APPLICATION NO.	FILING DATE	FIRST NAMED INVENTOR	ATTORNEY DOCKET NO.	CONFIRMATION NO.
09/941,655	08/30/2001	Hiroshi Kanazawa	381KA/50358	7423
7590	03/25/2005		EXAMINER	
			ELKASSABGI, HEBA	
			ART UNIT	PAPER NUMBER
			2834

Office Action Summary	Application No.	Applicant(s)	
	09/941,655	KANAZAWA ET AL.	
	Examiner	Art Unit	
	Heba Elkassabgi	2834

DETAILED ACTION

FIG. 2

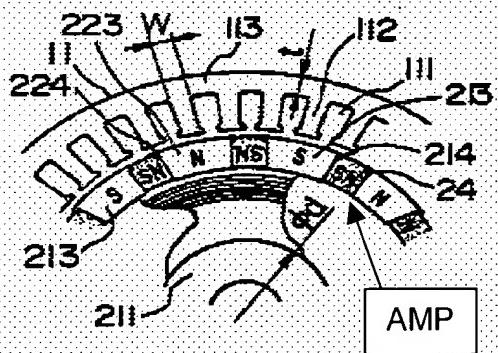
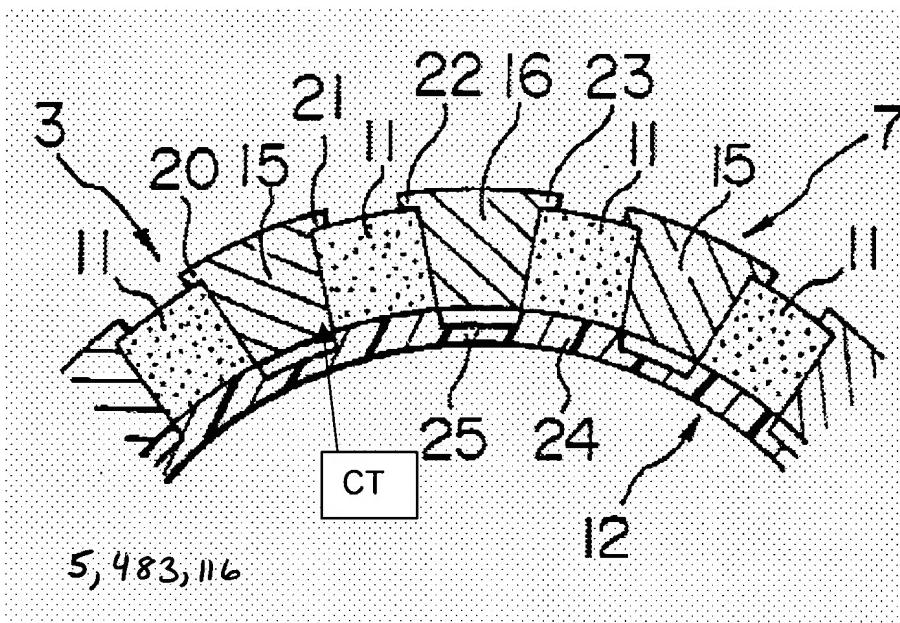
Kusase ('581) discloses above the claimed invention in addition to each claws (213,223) has an auxiliary magnetic pole portions (AMP) formed at circumferentially lateral ends, in which the auxiliary magnetic pole portions (AMP) form the opposing lateral surfaces of the claws (213,223) adjacent the permanent magnets (24) and have substantially the same rectangular shape as the magnetic pole surfaces with which they are in contact such that the lateral surfaces of the claws (213,223) are in contact with the whole of the magnetic pole surfaces of the permanent magnets (24). However, Kusase ('581) does not disclose a central portion of the claw having a triangular or trapezoidal shape.

Kusase et al. ('116) discloses in figures 1-3 a rotor (3) with claw-type magnetic poles (15) having a circumferentially central portion of each of the claws tapered (CT) towards a tip of each respective claw (15) and the circumferentially central portion has a substantially triangular shape in a radial section plane along an axial direction of the

rotor (3) and the claws (15) project radially inwardly from the circumferentially central portion of the claws (15).

It would have been obvious to one of ordinary skill in the art to combine the rotor structure of Kusase ('581) with the rotor claw pole structure of kusase et al. ('116) in order for to diminish the magnetic flux leakage between the claw-like poles.
